**Visions In Education**  
**TENANT IMPROVEMENT PROJECT**  
**Project # 24-01**  
**ADDENDUM NO. 1**

May 1, 2024

**1.5 Refer to Visions In Education, Bid Set Plans:**

**FP2.1**

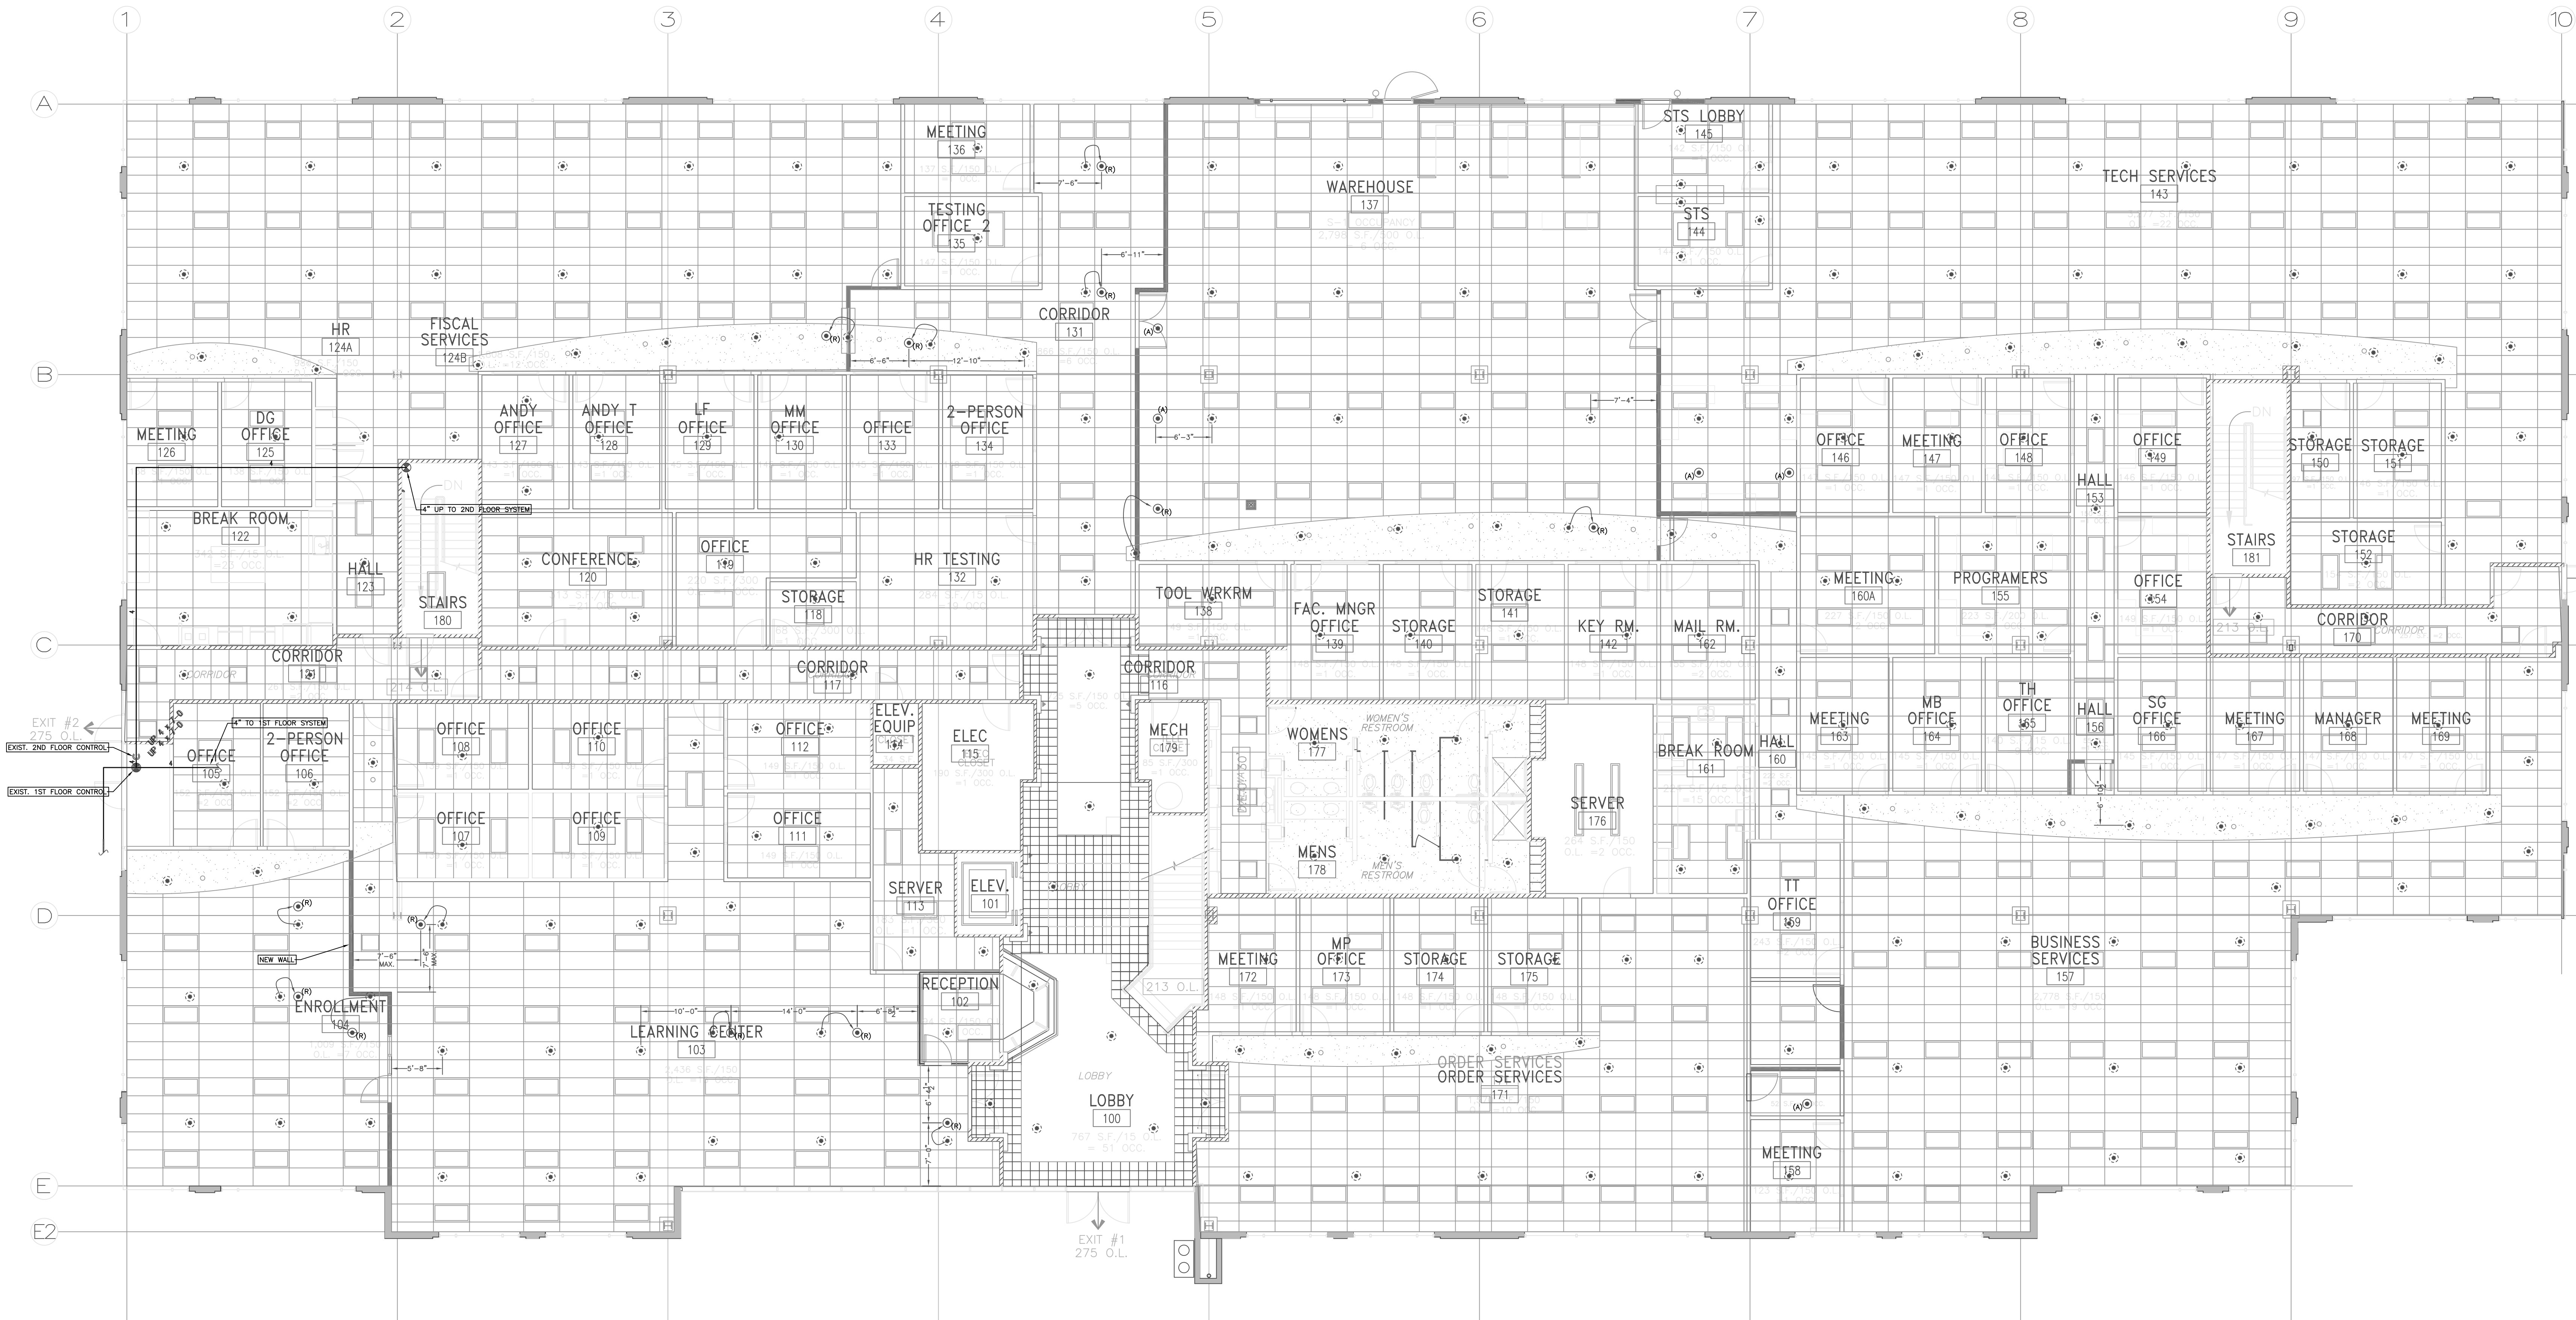
MODIFY SPRINKLER HEAD LOCATIONS TO ACCOMMODATE NEW WALLS AND LIGHTS IN TENANT SPACE.  
RELOCATE 28, ADD 23 AND PLUG 5.

- (R) RELOCATE = 13
- (A) ADD = 5
- (P) PLUG = 0
